E4443A-19

S E R V I C E N O T E

E4443A - PSA Series Spectrum Analyzer

Internal Alignment Failures for PSA Series Spectrum Analyzers Manufactured Between January 2004 and February 2006 Caused by Low Power Output from A9A1 DRO on A9 Second LO Assembly

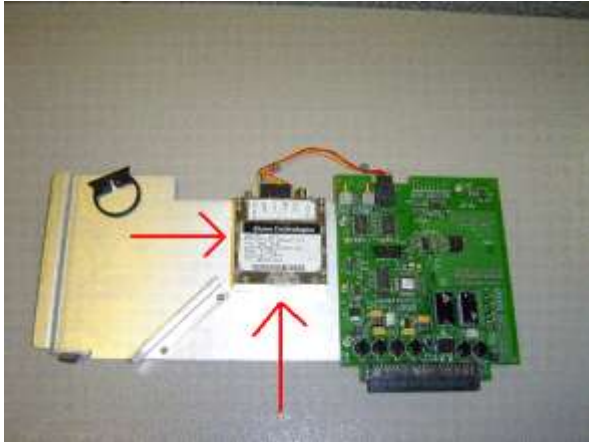
Verify the alignment failure by looking at the error queue for the error message “-340, Calibration failed, Align_2ND_LO_PWR”. Press [System] <Show Errors> <Next Page>. Typically, when the Second LO power is too low, it will be the first failure listed in the alignment queue, which will be at the bottom the Second page of alignment errors (as shown below):
